Permit Hearing - Item #11

Victory Rock

N3-24-003G

**Executive Summary**  
**Application for Operating Permit**  
**N3-24-003G**

**Figure 1. Middle Trinity CUWCD monitoring well N2-19-001P. The well location is shown in Figure 3.**

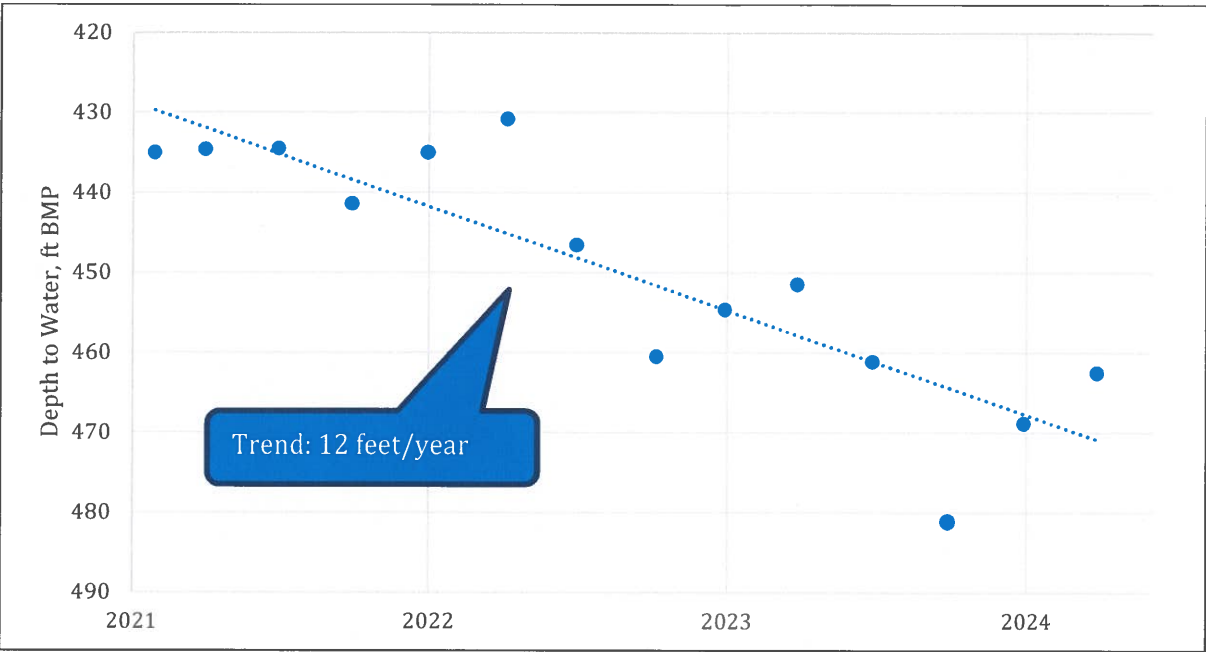
Based on data collected during the Victory Rock well pumping test, the depth to water in the Middle Trinity is currently about 476 feet below ground level. Based on monitoring well N2-19-002P and N2-19-001P, since the beginning of 2021 the Middle Trinity water level has been declining by about 12 to 13 feet per year (Figure 1 and Figure 2). Based on the top of the screen at 827 feet below ground level, is currently about 350 feet of water above the top of the screen with about 120 feet of regional water level decline per decade. The pump in the Victory Rock well is reportedly set at 750 feet below ground level, providing about 274 feet of submergence.

**Figure 3. The Victory Rock well and existing CUWCD active Middle Trinity wells.**

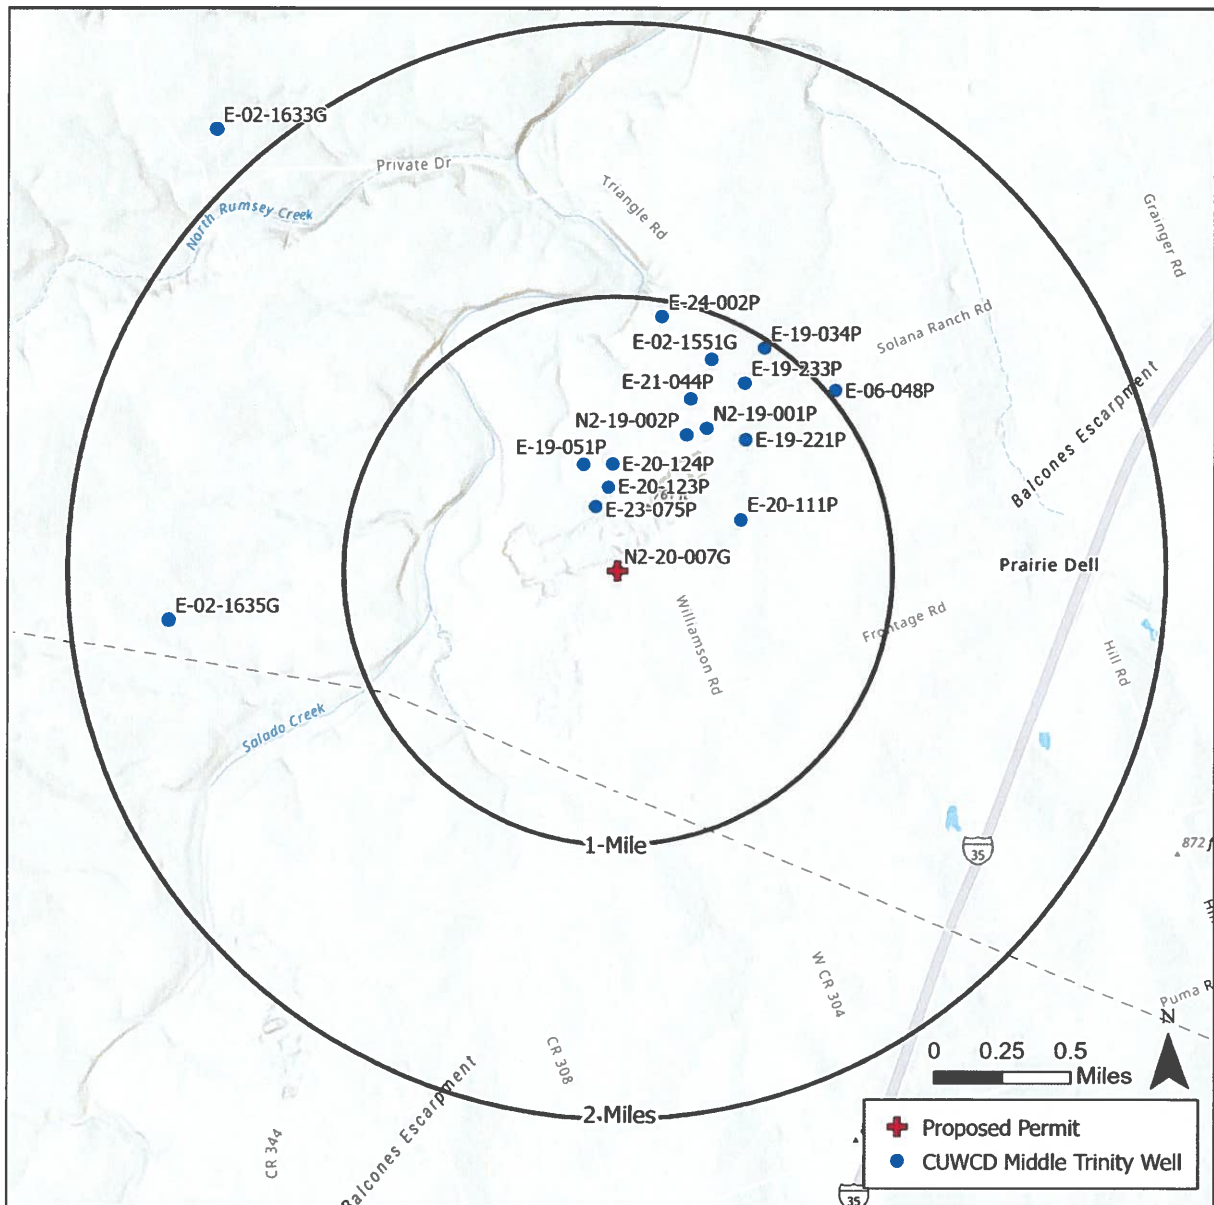
The Theis equation relates water level decline (that is, drawdown) to the pumping rate of a well and properties of the aquifer. While the equation does not account for aquifer conditions which may affect the calculation of long-term water level declines (for example: aquifer recharge, faulting, or changes in aquifer structure), it does provide a very good, reliable, and straightforward method for estimating relatively short-term drawdown in and near a well due to pumping. To assess the potential effects from the proposed production, the equation uses values representative of the Victory Rock pumping test results. We used these values to assess the potential drawdown at the proposed well and at existing wells located within two miles of the proposed well (Figure 3).

**Figure 4. Simulated additional drawdown at CUWCD Well ID E-23-075P after pumping at the three production scenarios for 50 years.**

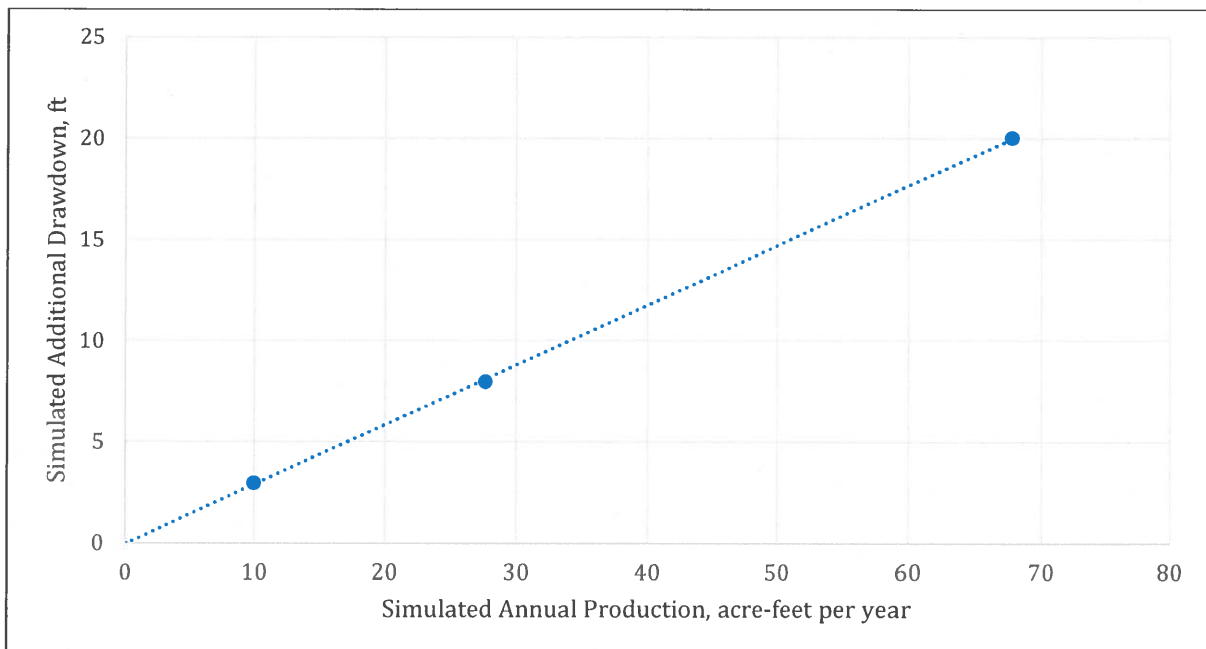
Figure 4 shows the simulated additional drawdown at the closest reported well, CUWCD Well ID E-23-075P, from the different production scenarios after pumping for 50 years. After 50 years of pumping at the Scenario A rate (10 AFY), the water level at the nearby well is estimated to drawdown about 2 feet and about 2 to 3 feet in Middle Trinity wells less than 1 mile away (Figure 5). For Scenario B (27.62 (AFY), the water level at the nearest well is estimated to drawdown about 8 feet and about 7 to 8 feet in Middle Trinity wells less than 1 mile away (Figure 6). For Scenario C (67.75), the water level at the nearest well is estimated to drawdown about 20 feet and about 16 to 20 feet in Middle Trinity wells less than 1 mile away (Figure 7).

**Figure 5. Simulated additional drawdown due to the Victory Rock Middle Trinity well pumping at the Scenario A rate (10 AFY) for 50 years.**

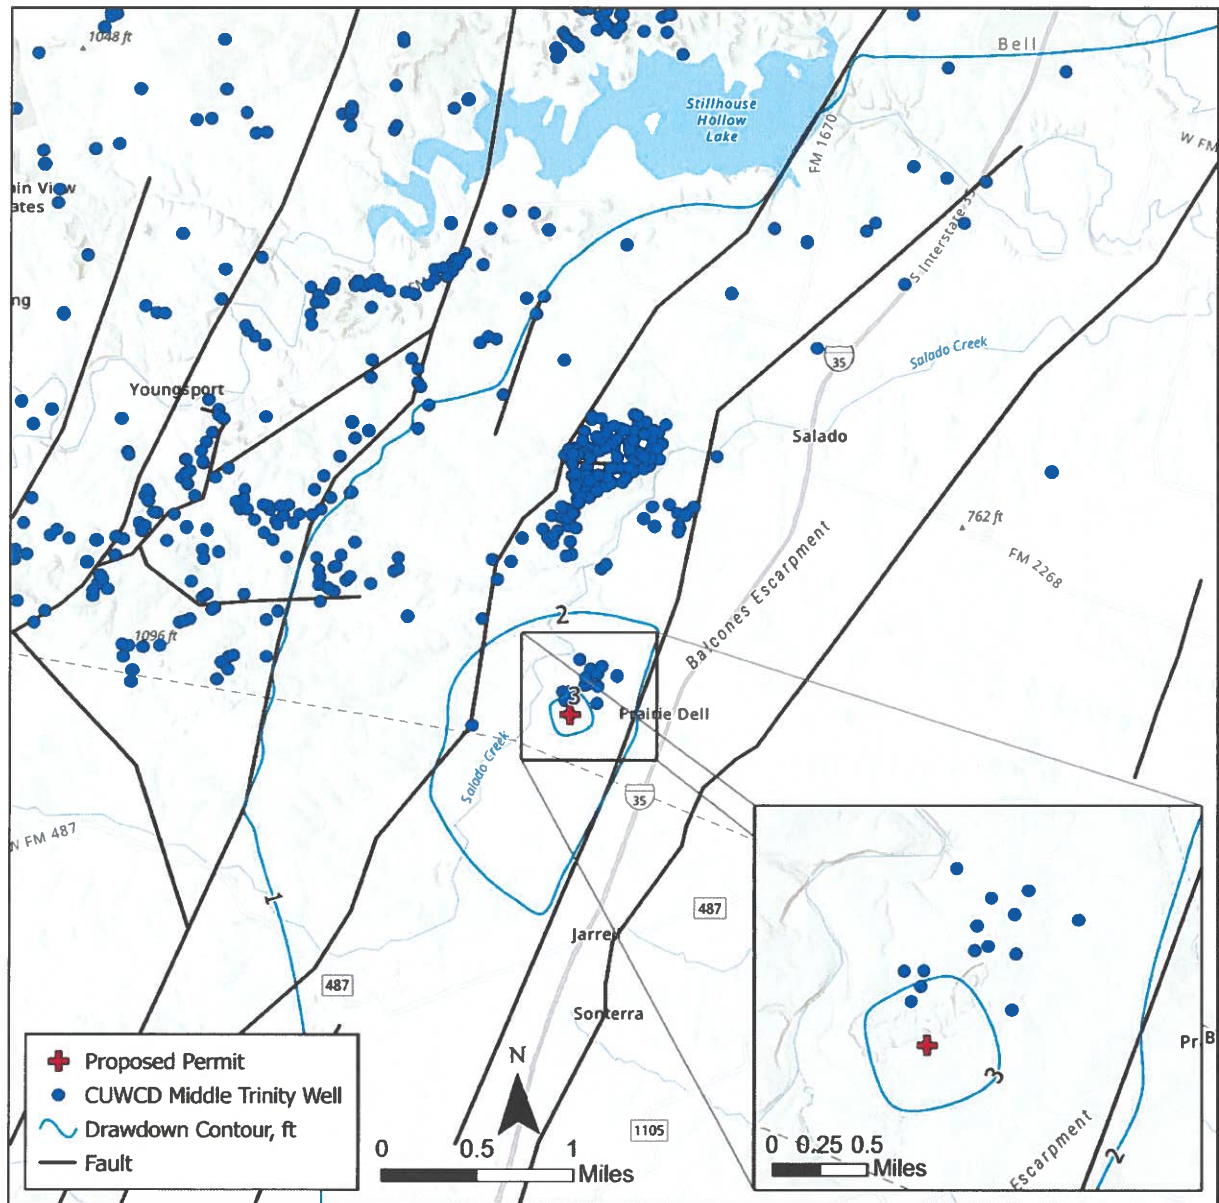
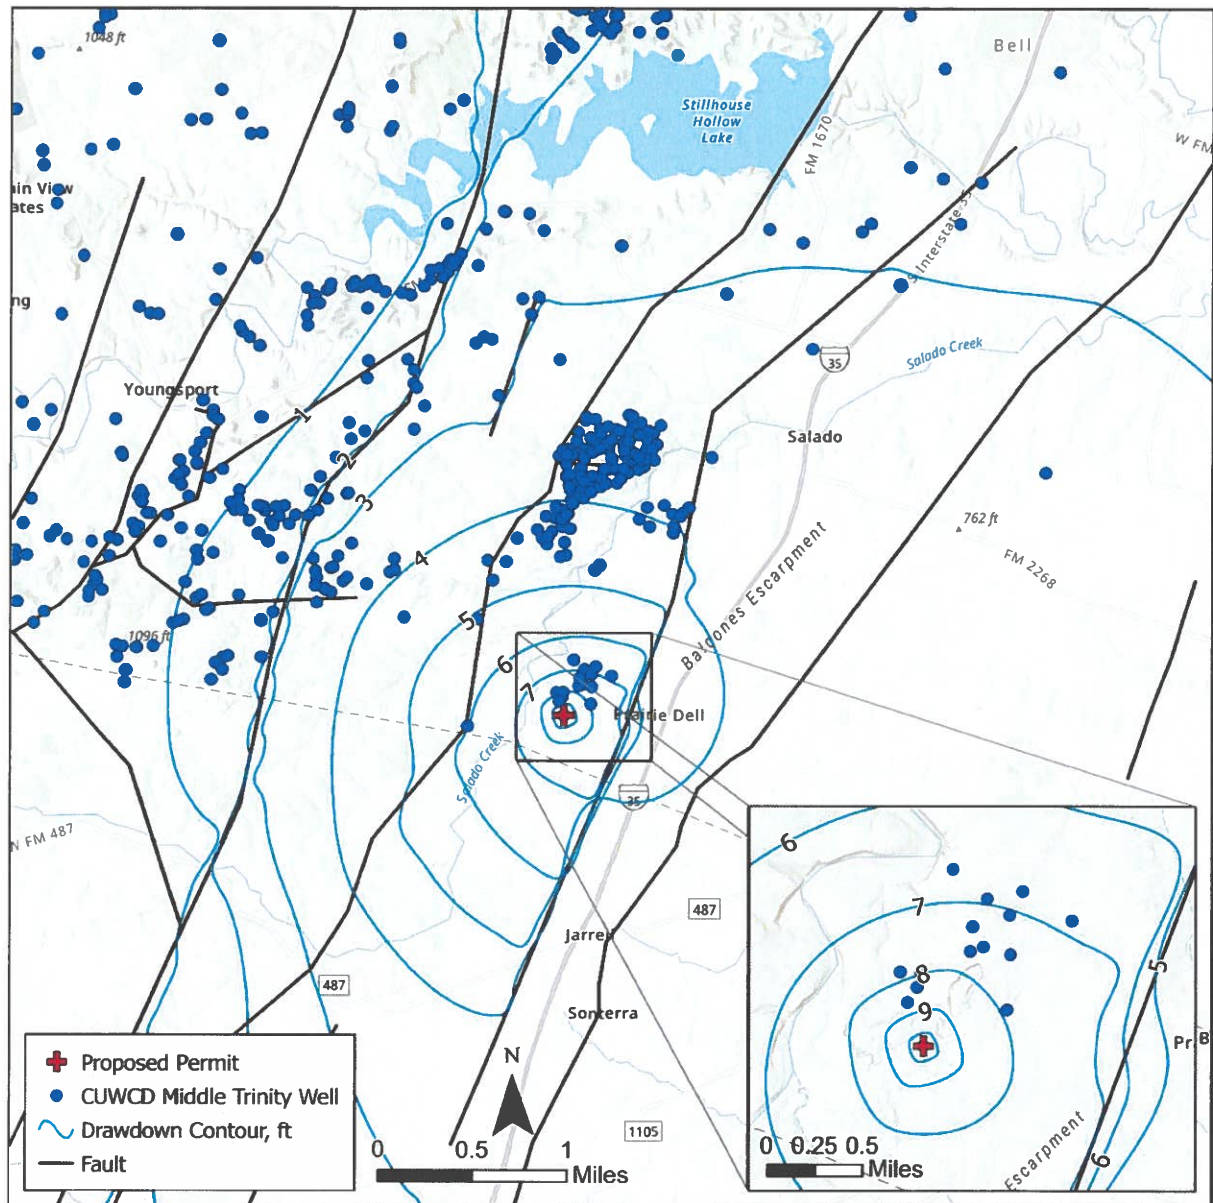
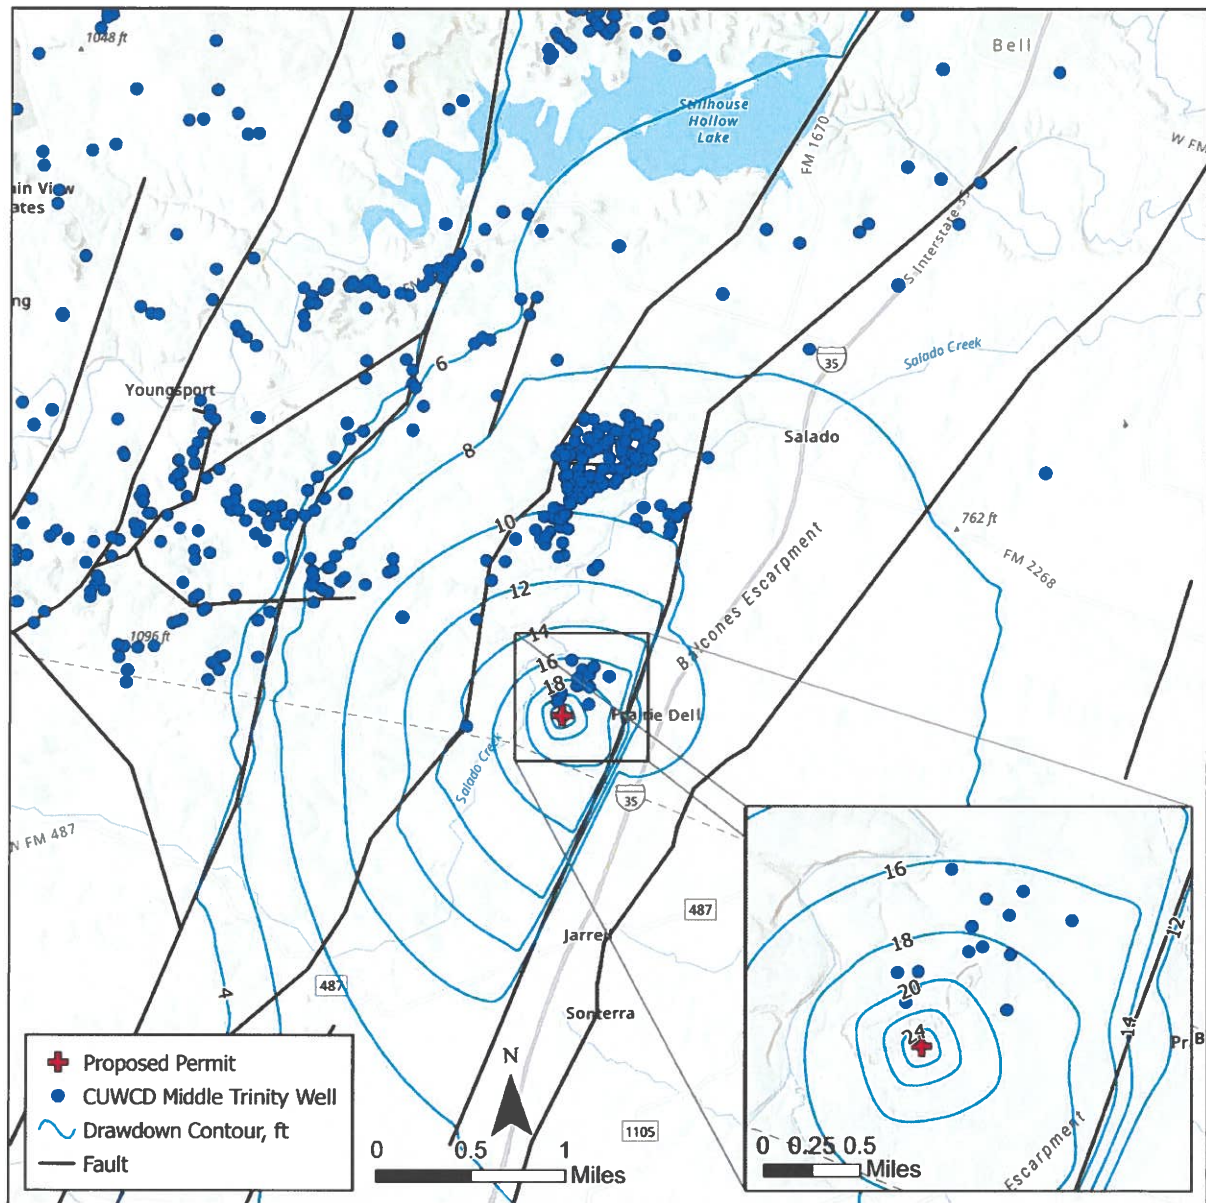
Figure 5 through Figure 7 also show the effects of the fault just east of the proposed production. Most of the drawdown occurs on the western portion of the fault due to the modeled sealing properties of the fault. If the fault is less sealing than the model indicates, then we would expect more drawdown to occur east of the fault, resulting in less drawdown west of the fault.

lower bound on the range of possible pumping that could result in one foot or less of additional drawdown at E-23-075P.
